H TECHNICAL BULLETIN

HKA250 SUSPENSIONS WITH 16-INCH RIDE HEIGHT

SUBJECT: Air Spring Plate Installation

LIT NO: B107

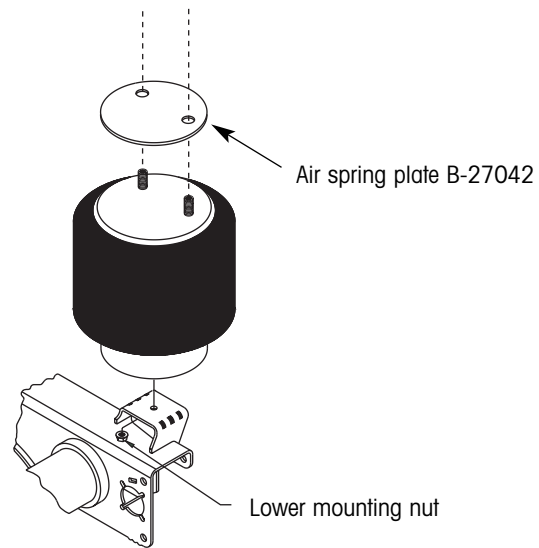
To prevent air spring top plates from cracking on HKA250 suspension models with 16-inch ride heights, Hendrickson is recommending the installation of four air spring plates. These plates are part of reinforcement kit S-27316-1, which also includes parts designed to reinforce the slider box K-brace frame rails on HKA250 suspensions (refer to Hendrickson publication B-108, *K-Brace Reinforcement Installation*, for complete K-brace reinforcement installation procedures). The air spring plates are to be installed between each air spring and the slider box on all 16-inch HKA250 suspensions equipped with C-23748 air springs.

8. If the air spring is known to be leaking, replace it. Otherwise, continue with step 9.
9. Place the air spring plate (part number B-27042) on top of the air spring.

10. Raise the air spring/plate assembly back into position, insert the mounting studs through the holes in the slider box subassembly and tighten the upper mounting nuts to a torque of

80-100 ft. lbs. (108-136N•m). If the entire air spring was replaced, tighten the lower mounting nut to a torque of 40-50 ft. lbs. (54-68N•m).
